Ft. Collins/Poudre - I-25 MM 268
Elevation \approx 5000'

Summary Observations

An on-site ADA survey was conducted August 31, 2016, by Patrick Going, ADA Consultant. All observations are based on the *2010 ADA Standards for Accessible Design*. These Standards may be found at www.access-board.gov.

Path between rest area building and Visitor Center

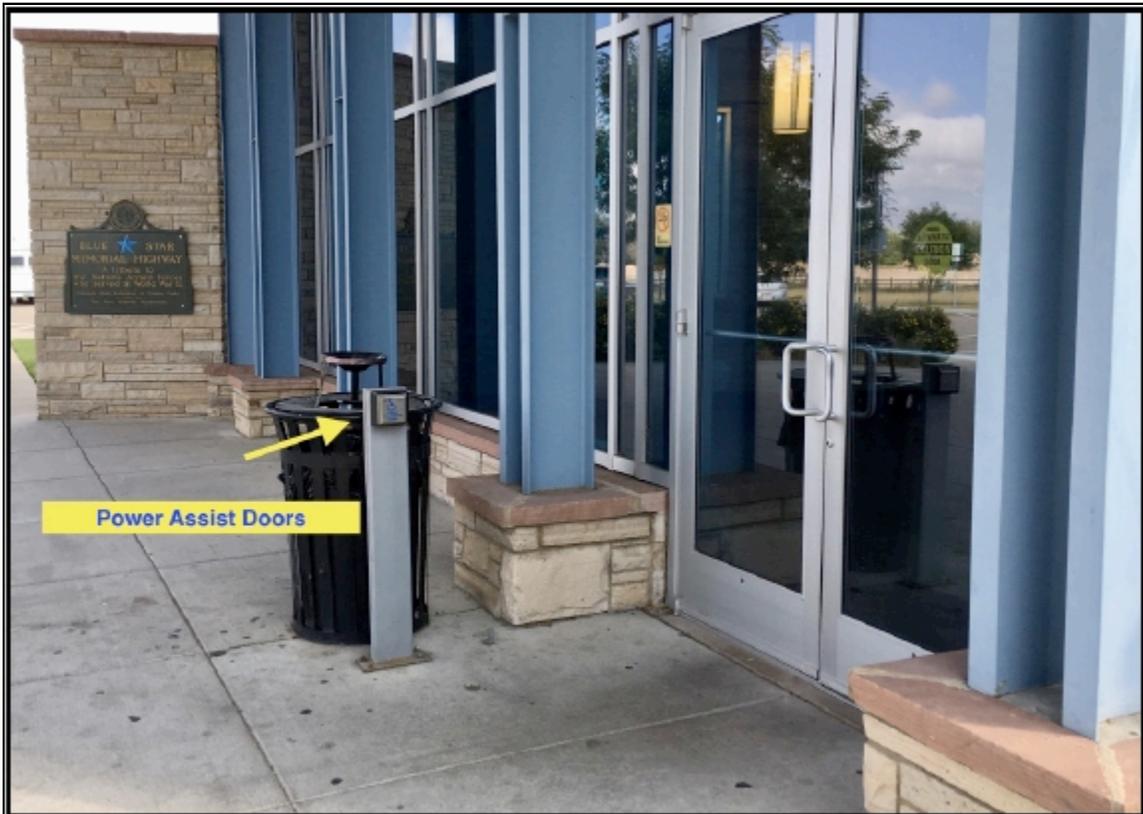
This 2" edge is on route from rest area to nearby Welcome/Visitor Center

Recommendations	
Description	Priority
Add restroom signs on wall on latch side of doors 60" high	Immediate
Grind down 2" lip on concrete path to Welcome/Visitor Center	Soon
